RESPONSE TO COMMENTS ON THE DRAFT INITIAL STUDY/ MITIGATED NEGATIVE DECLARATION

Getaway House, Inc. Major Use Permit
State Clearinghouse (SCH) No. 2020040111
October 15, 2020

Figure 2, Preliminary Site Design, reproduced below, shows the areas of proposed development (please note the irregularities in the figure below, which make it very difficult to read, are directly from the environmental documentation).

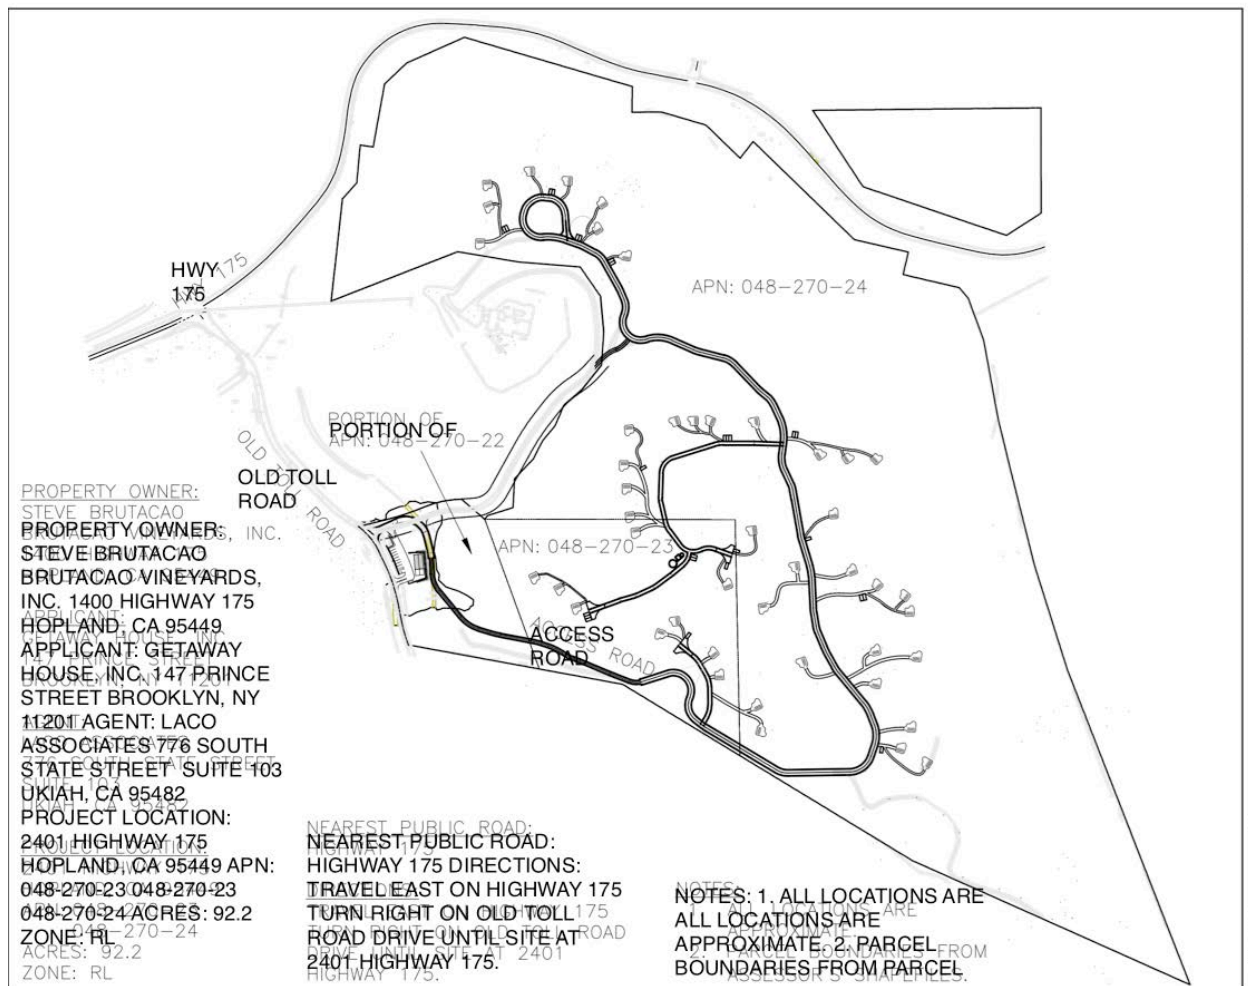
Discussion: The Draft Initial Study does not adequately assess project impacts to the site's oak woodlands. Instead it simply lists oak species on the site and provides a figure of 5.49, which appears to be erroneous, as an estimate of the total area that will be disturbed:

Comparing that map (as well as the map in Appendix B) and the Subject Parcel(s) map, it appears that the figure of 5.49 acres of impact is incorrect, as is the estimate of 6.05 percent. While it may be correct that road construction and widening activities will remove approximately 6.05 percent of the site's natural area, the preliminary site design map shows a much larger area that is fragmented.
